This document is a response to the Jamaso (DA-2243-00) Initial Technical Submission (4th Overall Review) comments received on July 27nd, 2022 by the Office of Development Assistance. Responses are below in **RED**:

Initial Technical Submission Review

Jamaso
Aurora, Colorado
Sanitary Sewer System Map

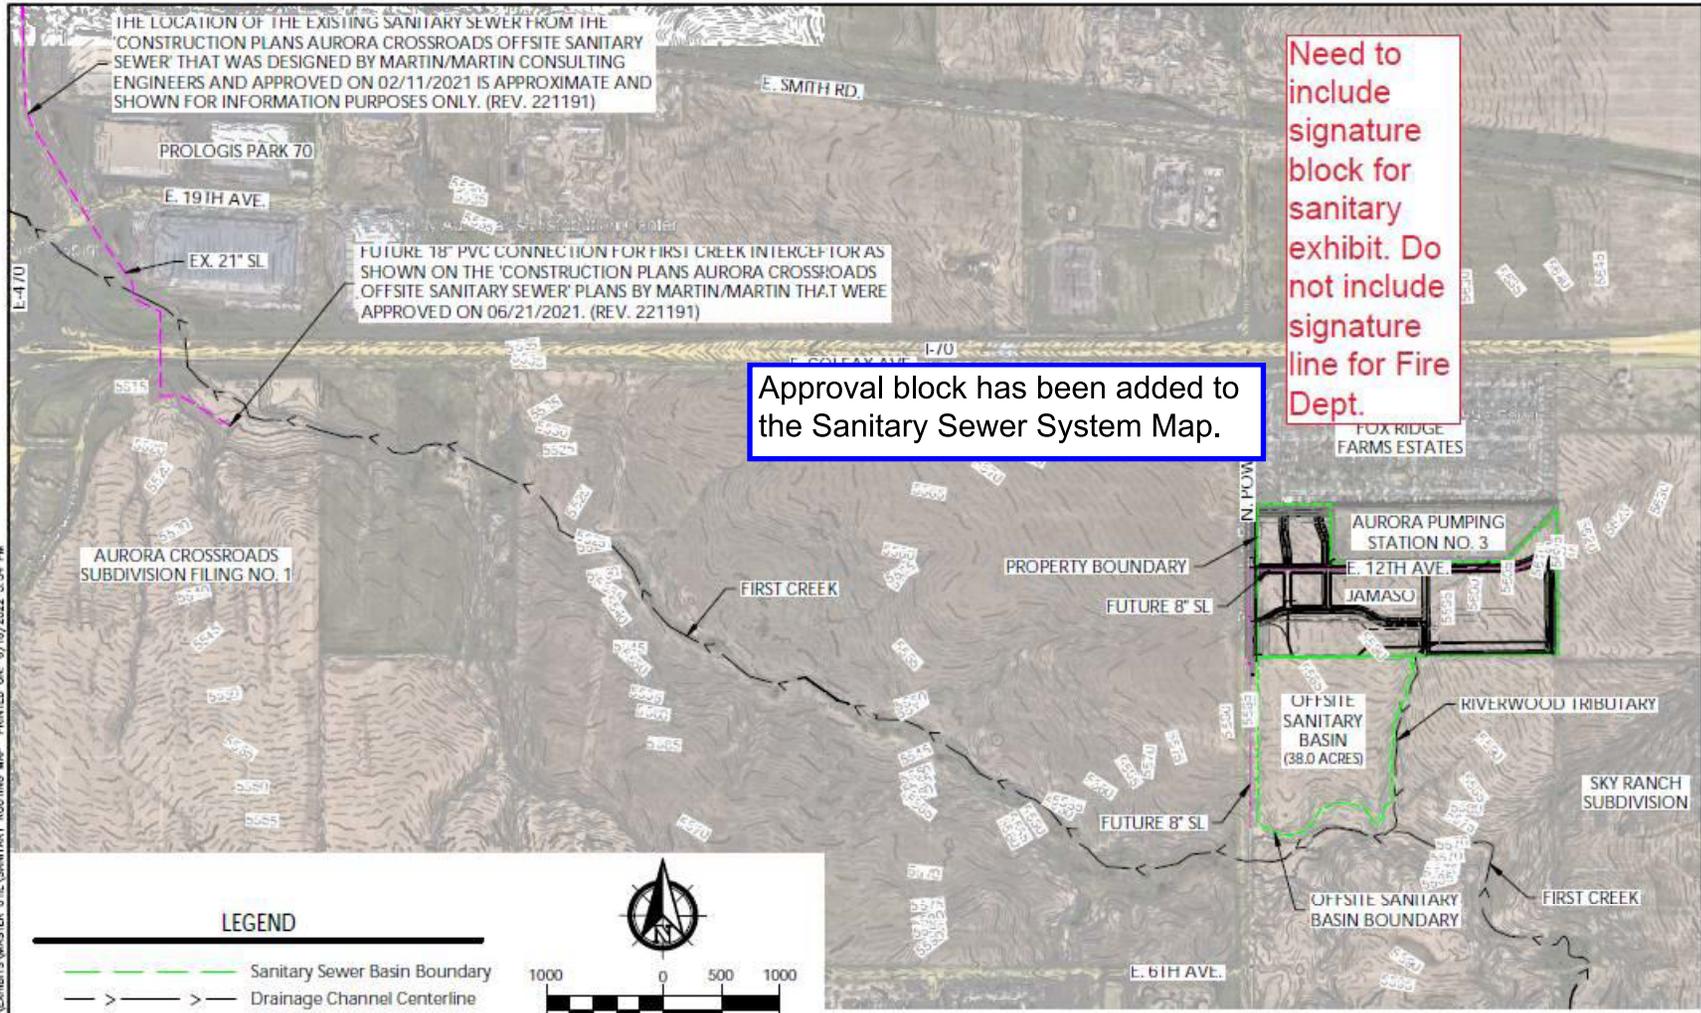
Need to include signature block for sanitary exhibit. Do not include signature line for Fire Dept.

Approval block has been added to the Sanitary Sewer System Map.
